Bexley Planning Commission

Planning Staff Report – July 25, 2016

Bexley House Apartments Signage

Application #: 16-011

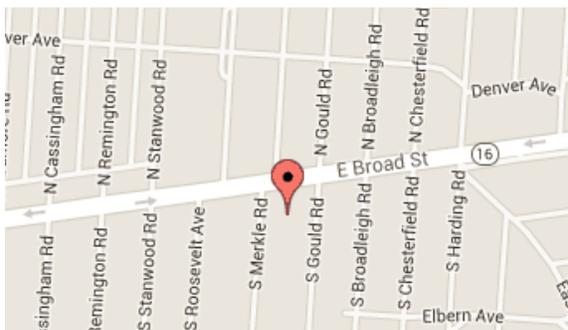
The applicant has proposed replacement signage and replacement of the existing extended awning-style entry canopy with an architectural canopy as well as new paving materials at the entry and painting of specified areas.

Staff is generally in favor of the architectural elements as proposed.

The Tree and Public Garden Commission reviewed the proposed wall and signage. Their primary concerns were the size and materials and location of the proposed wall and signage due to the proximity to existing Bexley gateway features. Staff agrees with these concerns. The applicant has specified the wall and signage location in conformance with right-of-way setbacks and adjusted the materials, but have not adjusted the size of the wall and signage.

Staff recommends further refinement of the design approach to the signage, with several conditions outlined at the end of the report and based on the considerations below.
